Groundwater Transfer Review Summary Form

Transfer/PA # T- 14539

Application: T-14539

Applicant Name: FNF NV Brasada LLC

Transfer Map

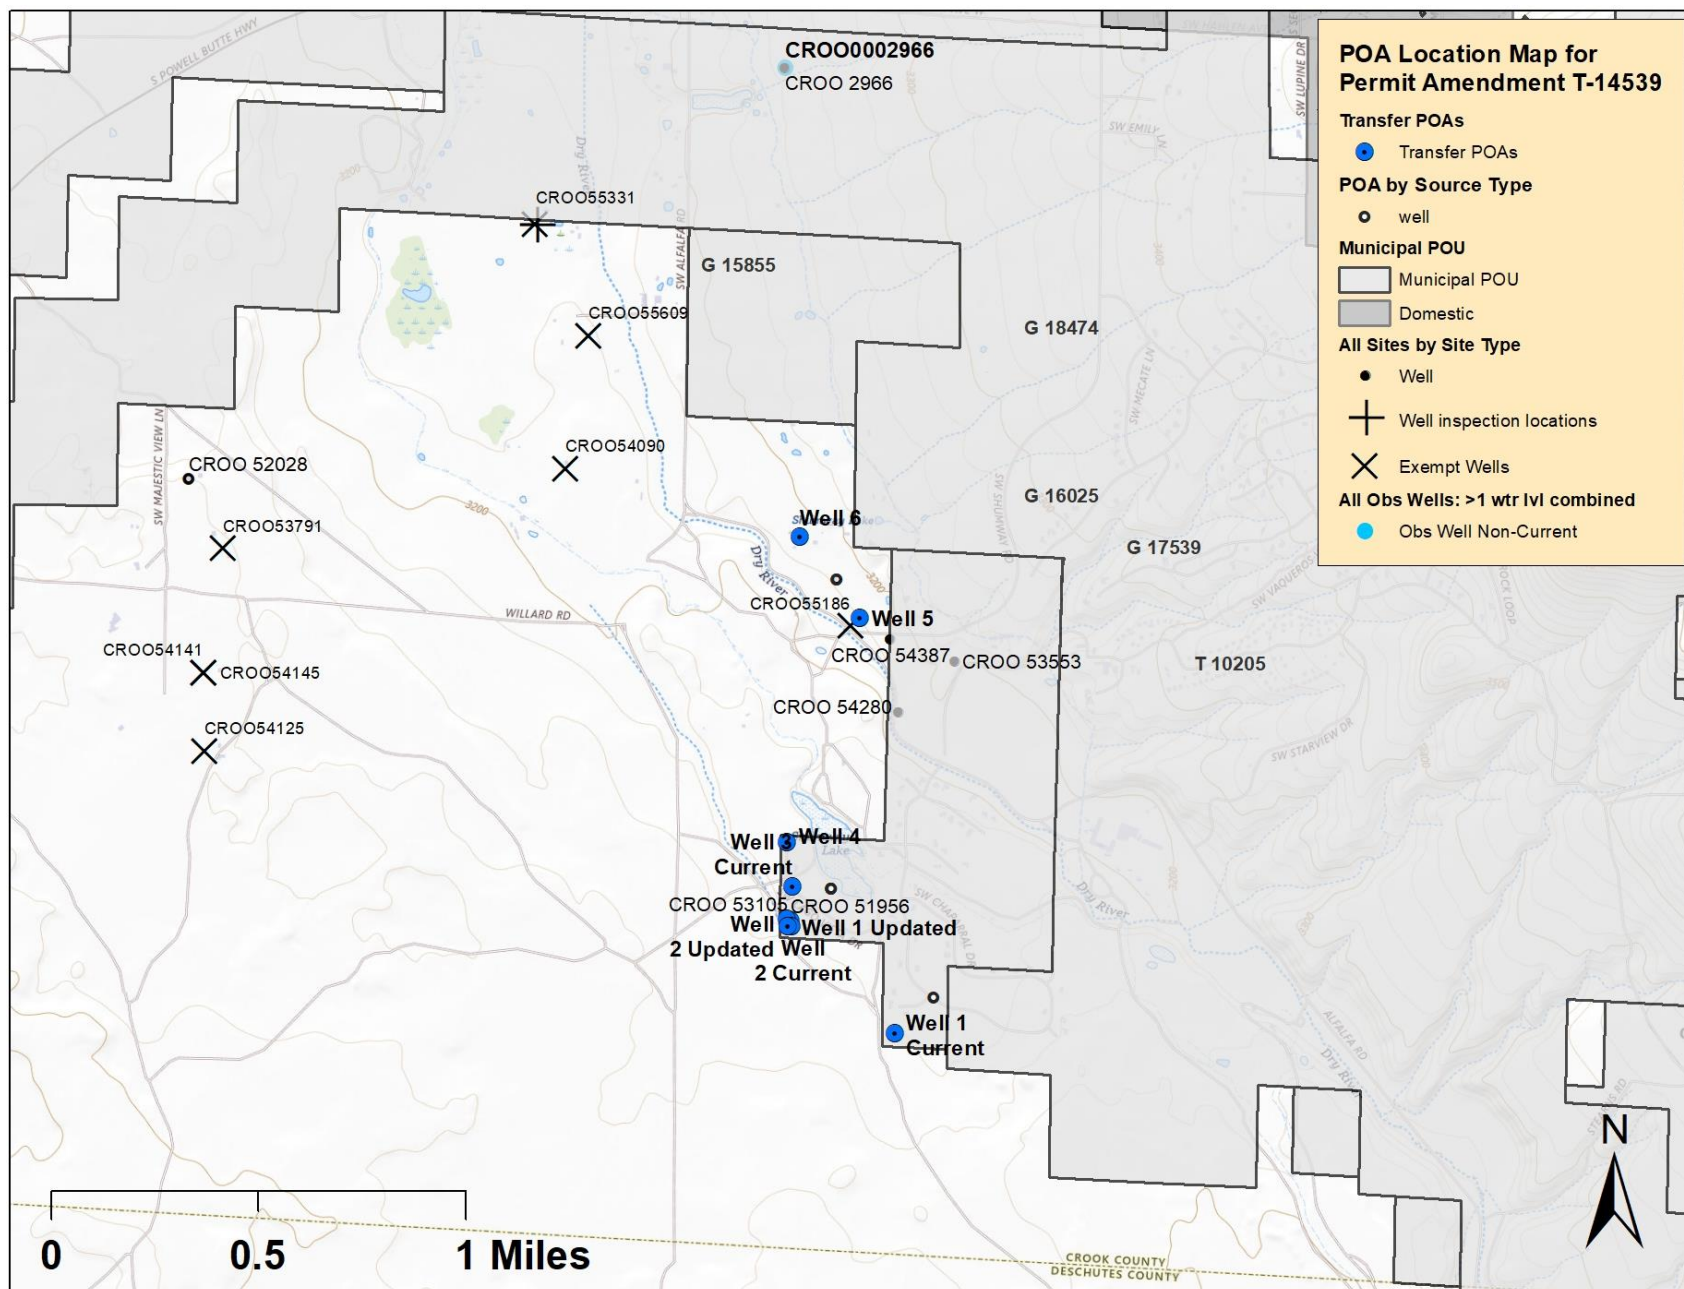
-
1. Basic description of the changes proposed in this transfer: Permit G-15855 authorizes 3.34 cfs up to 508 AF/yr of quasi-municipal use from 6 wells. This permit amendment proposes the change the location of three authorized POAs on G-15855. See well table below for details.

☐ Yes ☒ No Comments: There is moderate domestic groundwater development to the west and northwest of the applicants wells. The closest wells are ~0.5 miles from applicant's Well 5 and 6. The changes to POA location are very minor and would likely move groundwater pumping away from these adjacent domestic wells. This would maintain or reduce any current well-to-well interference. There are other valid POAs under G-18151, but those are part of the same water supply system and thus are not considered for injury here. Generally speaking, the target aquifer is relatively transmissive, resulting in low magnitude well-to-well interference. There is some concern that the Deschutes formation here pinches out as it onlaps Powell Buttes to the east, which increases the likelihood that a groundwater well would fully penetrate the aquifer and thus be vulnerable to injury. However, there is little to no groundwater development in that direction adjacent to the applicant's wells.

Water Levels in Adjacent Wells:

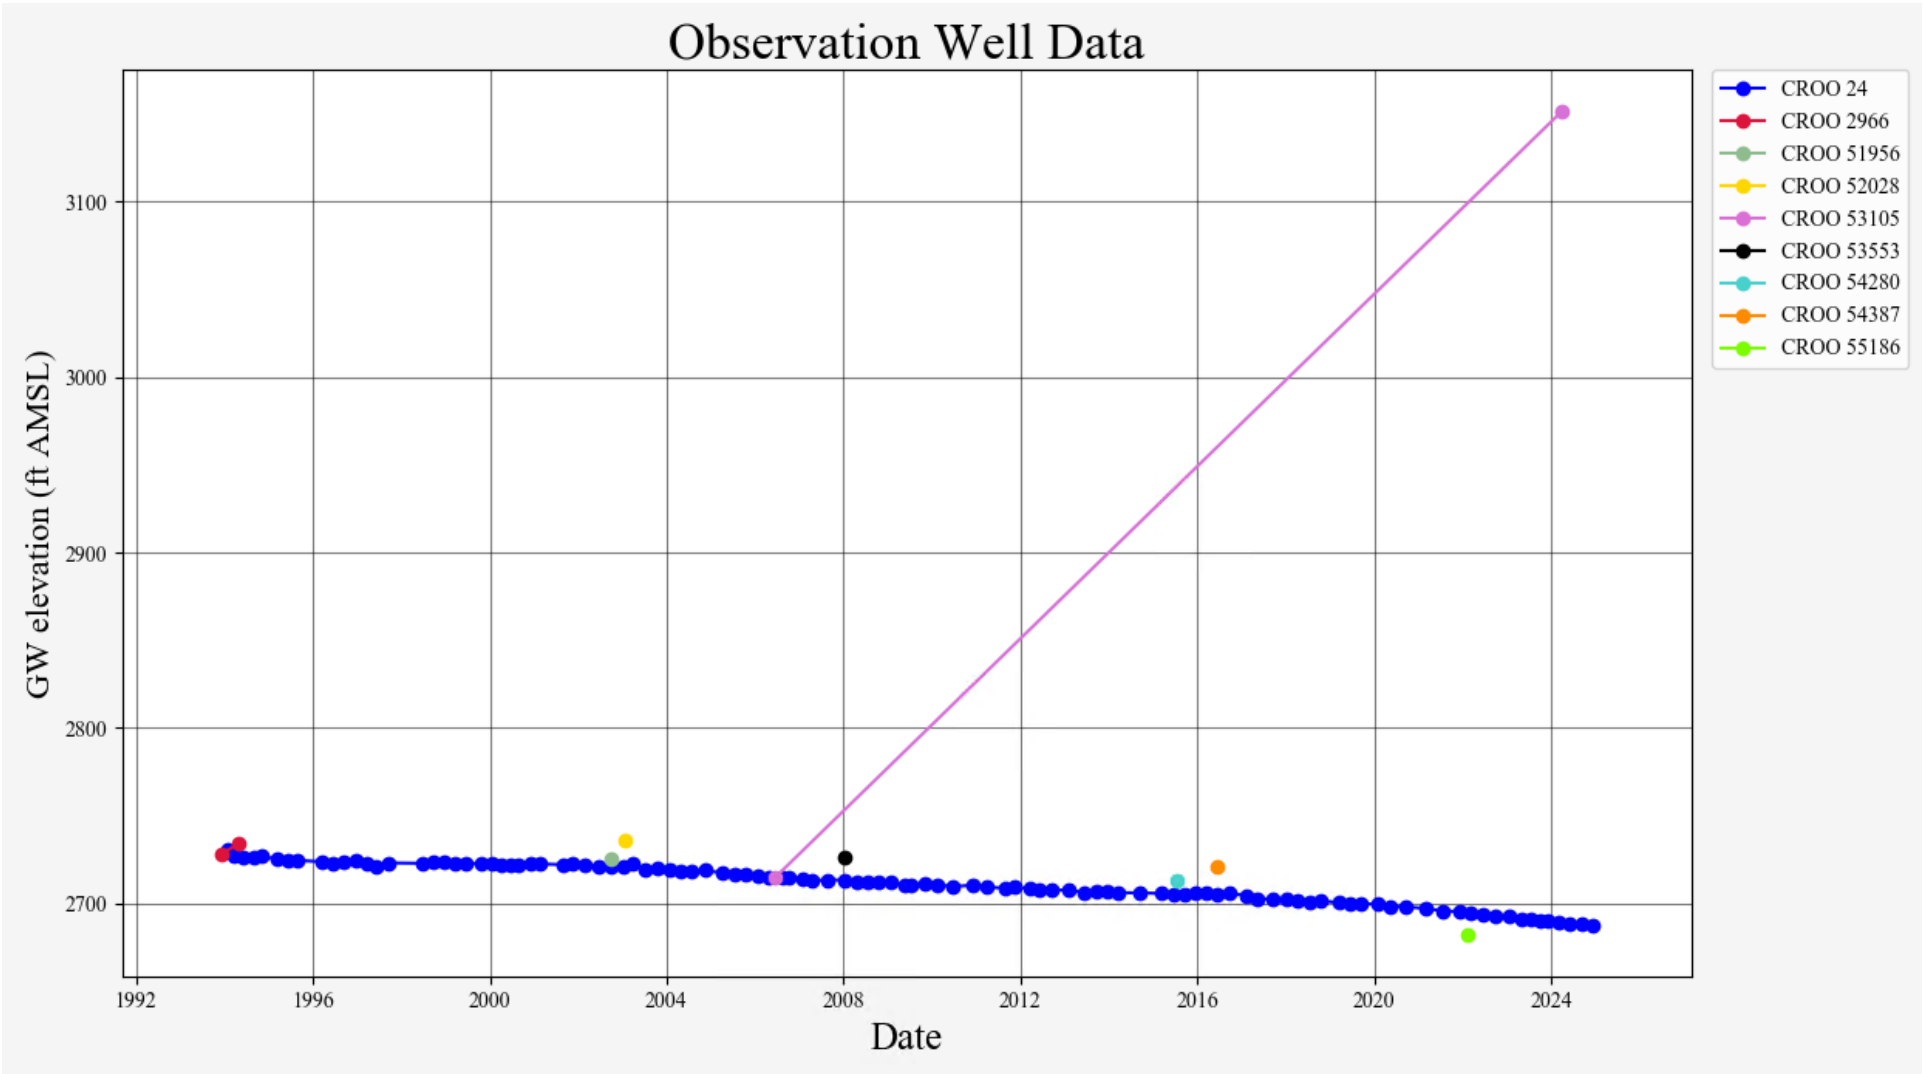
2. Will the proposed POA develop the same aquifer (source) as the existing authorized POA?
☒ Yes ☐ No Comments: The changes in POA location will not result in accessing a different source. CROO 53105 has a recent water level measurement that is much shallower than the regional aquifer (~2700 ft amsl) but this may be a result of seasonal canal leakage or an unreliable measurement. Considerable supporting information would be required to conclude that this well accesses a different groundwater source.
